service bulletin

NUMBER: 79-8 DATE: 3/23/79

A. MERCRUISER SHIFT SHAFT TOOL

Figure 2. Tool Installed on Gear Housing Shift Shaft

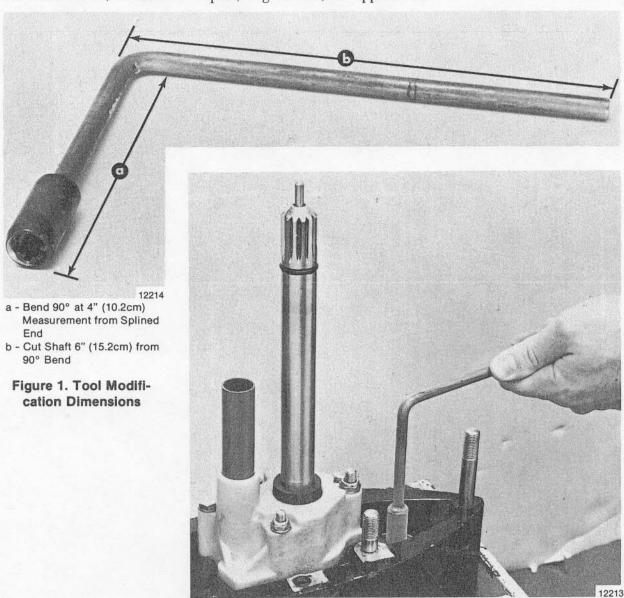
Shift Shaft C-75104A7 now is available to you and can be modified (as shown in Figure 1) to use when checking gear backlash in MerCruiser I gear housings. (Figure 2) Refer to MerCruiser Service Manual, Drive Unit Repair, Page 6A-11, for application.
